PLANNING & DEVELOPMENT DEPARMENT
DEVELOPMENT REPORT

To: City of Corinth Planning and Zoning Commission
From: Michelle L. Mixell, AICP, Planning and Development Manager
RE: **Application #RP20-003** – Lake Dallas High School (LDISD) Replat

Enclosure (1) Replat Exhibit with DRC Comments – 1st DRC Review 9/22/20

LOT 1R-2, BLOCK A
LAKE DALLAS ISD SCHOOL ADDITION

UPdate → **AUGUST 2020** **SHEET 1 OF 2**

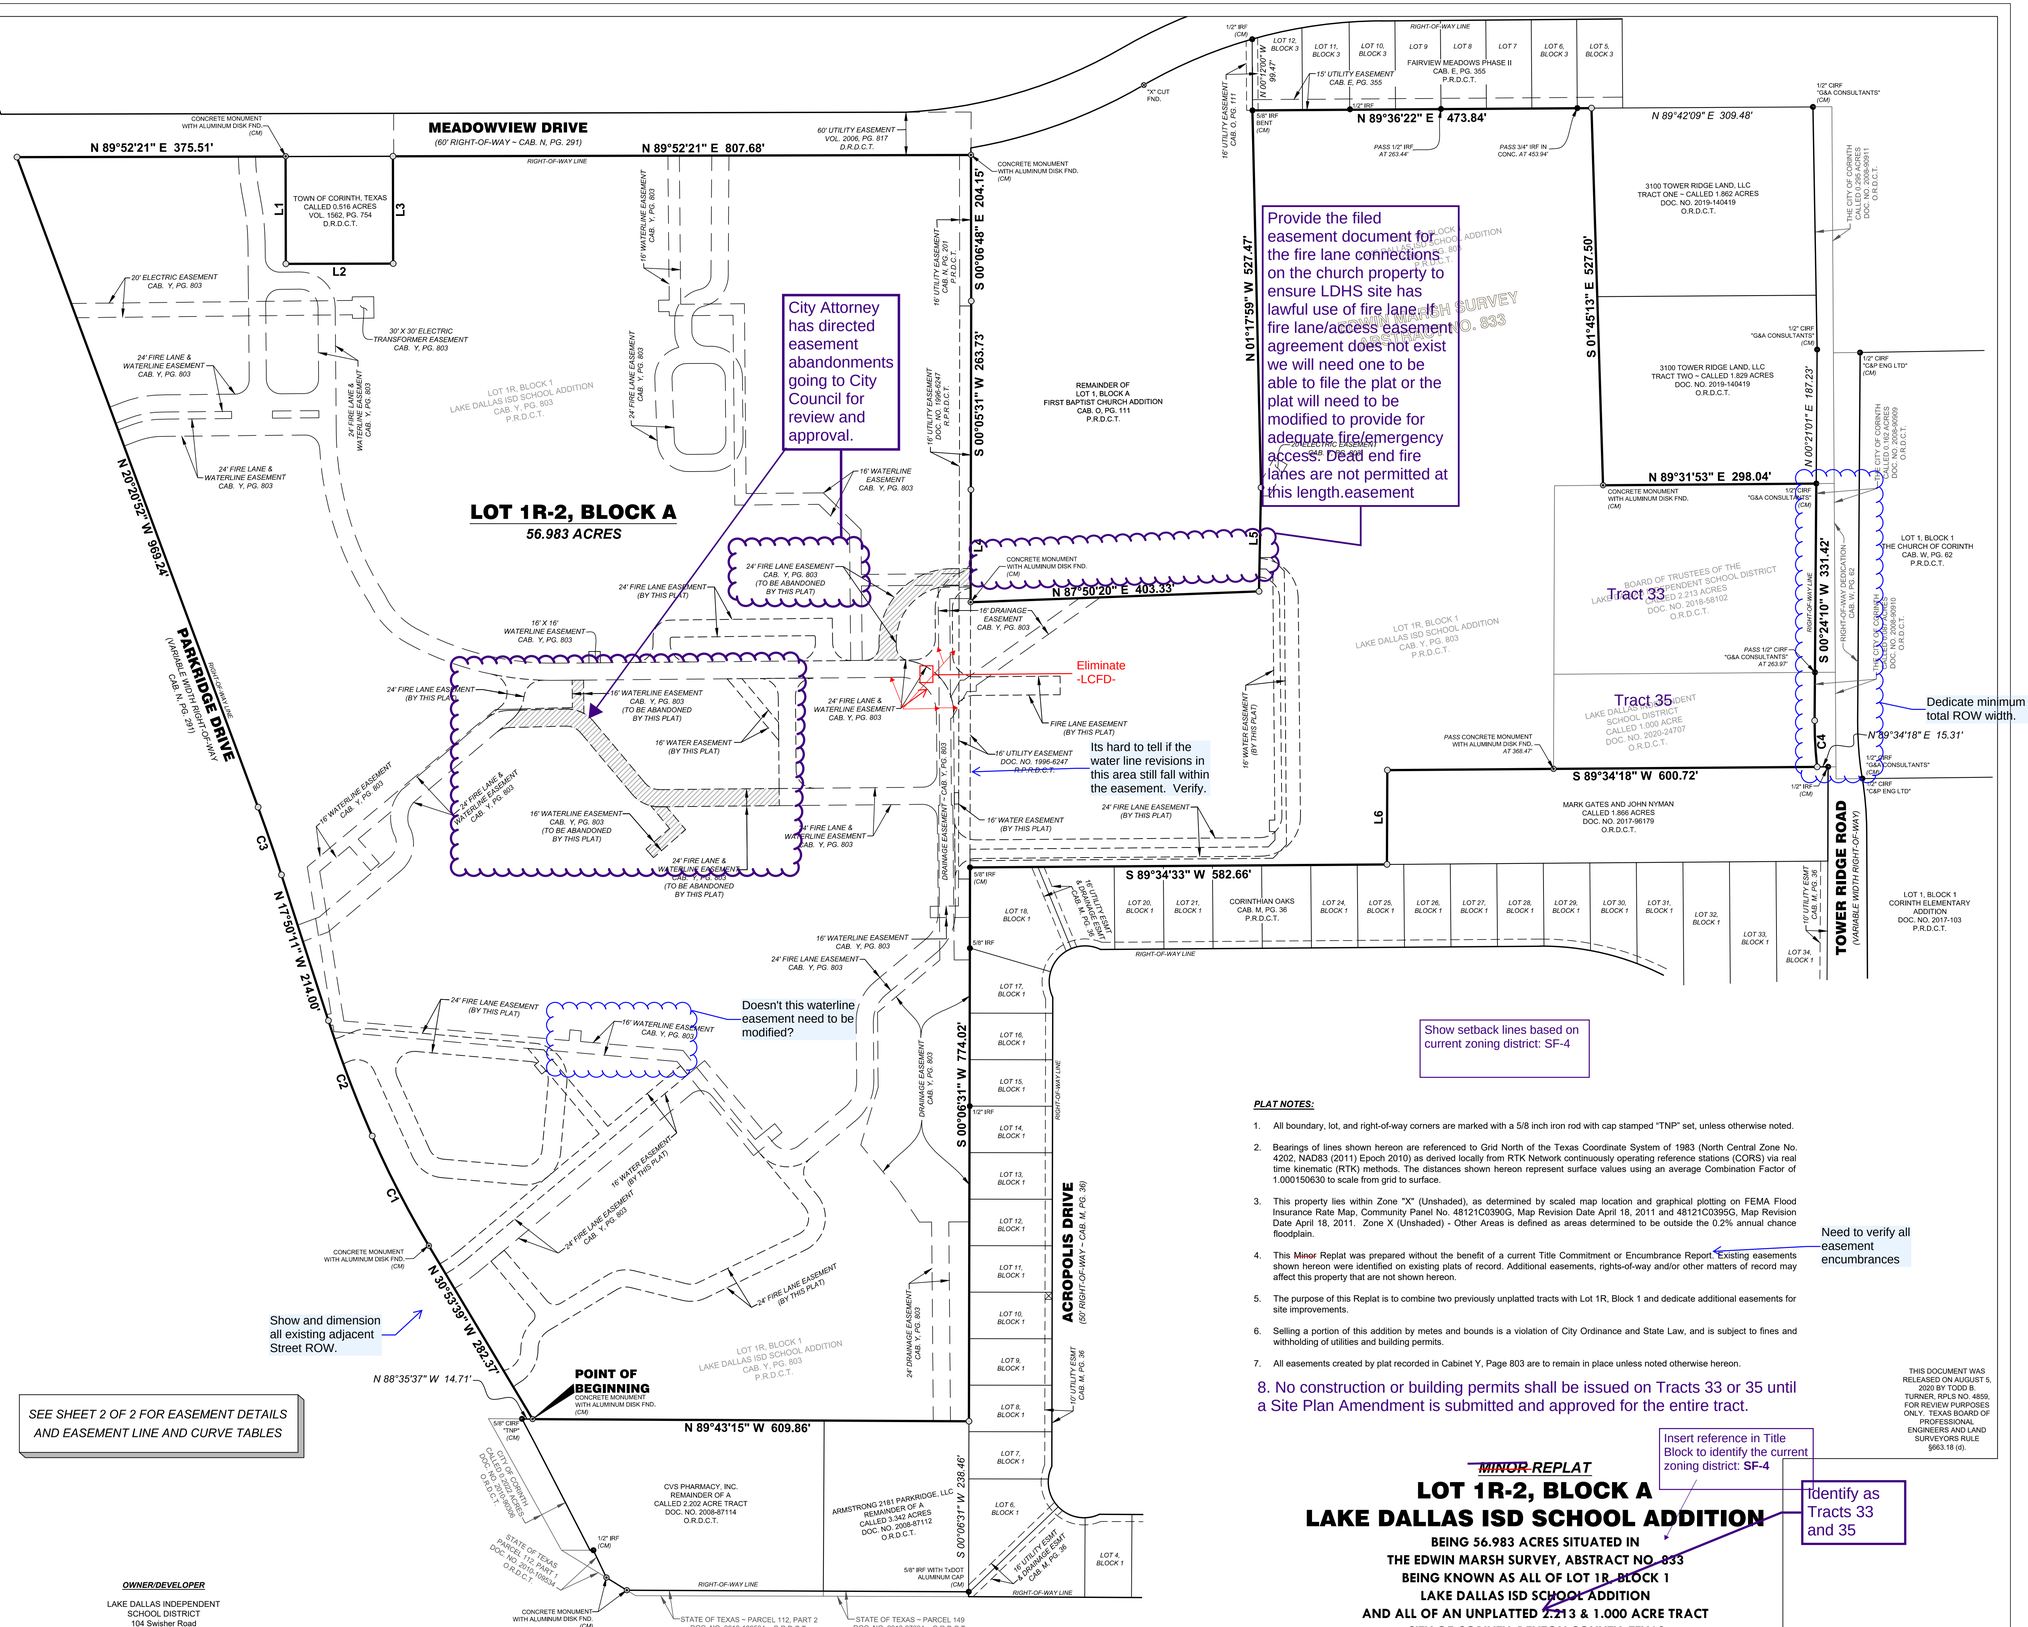
Development Review Committee (DRC) Summary Comments. 1st DRC Review 9/22/20	
Planning Review Comments:	Date Resolved:
1. Identify as Tracts 33 and 35 in title block and add a reference to Tracts 33 and 35 in Plat Notes #5 and label the plat sheets accordingly.

6. Provide the filed easement document for the fire lane connections on the church property to ensure LDHS site has lawful use of fire lane. If fire lane/access easement agreement does not exist we will need one to be able to file the plat or the plat will need to be modified to provide for adequate fire/emergency access. Dead end fire lanes are not permitted at this length.

Engineering Review Comments:	**Date Resolved:**
1. Dedicate minimum 60' total ROW width.	
2. Doesn't this waterline easement need to be modified?	
3. Need to verify all easement encumbrances	
4. Show and dimension all existing adjacent Street ROW.	
5. It's hard to tell if the water line revisions in this area still fall within the easement. Verify.

Public Safety Review Comments:	Date Resolved:
1. 24' FIRE LANE (See highlighted and Comments in RED from Fire Department)	
2. Eliminate -LCFD – see arrows on plat sheet	
Building Review Comments: No Comments.	Date Resolved:

Need to verify all easement encumbrances

Insert reference in Title Block to identify the current zoning district: **SF-4**

Identify as Tracts 33 and 35

~~*MINOR*~~ *REPLAT*

EASEMENT DETAIL MATCHPOINT

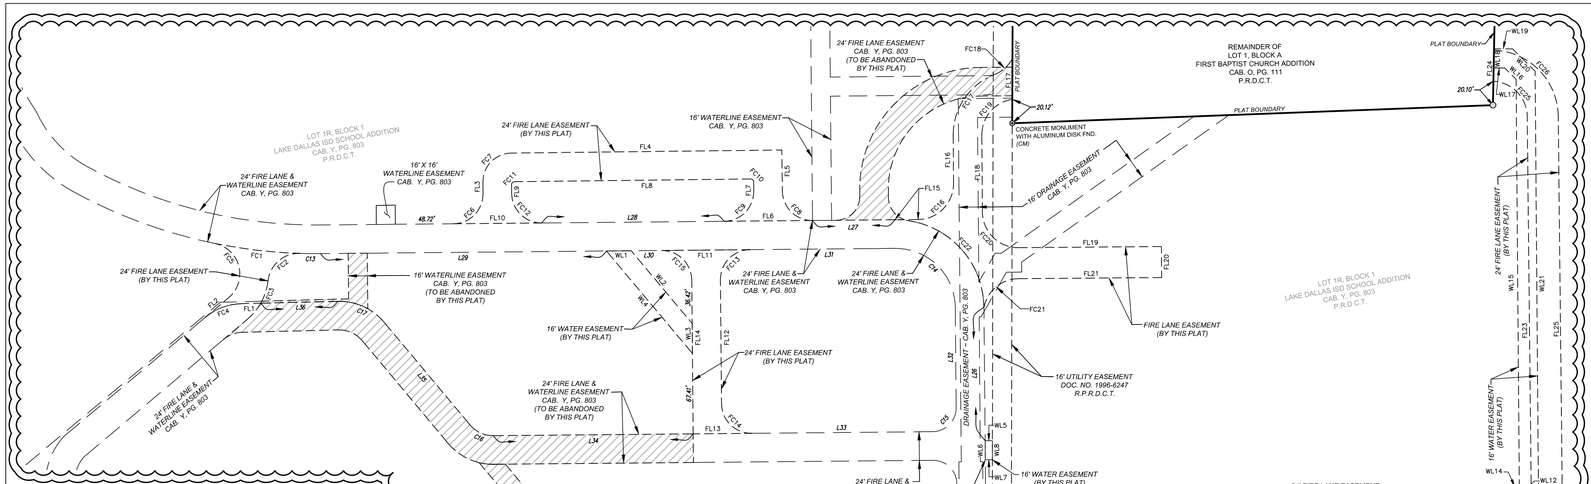
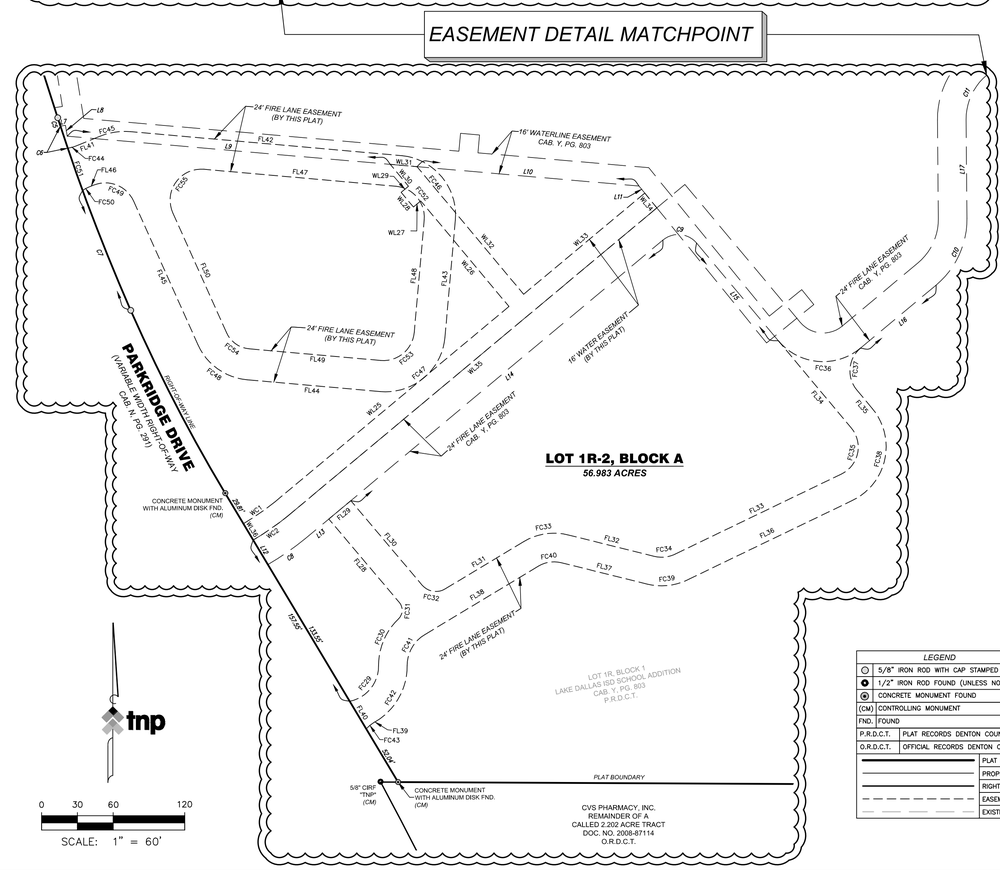
Add the term "Replat" to the Certificate of Approval language

Remove the term "minor" from title block language and as may be referenced elsewhere on the plat sheets. Change to "Replat".

Identify as Tracts 33 and 35

~~*MINOR REPLAT*~~
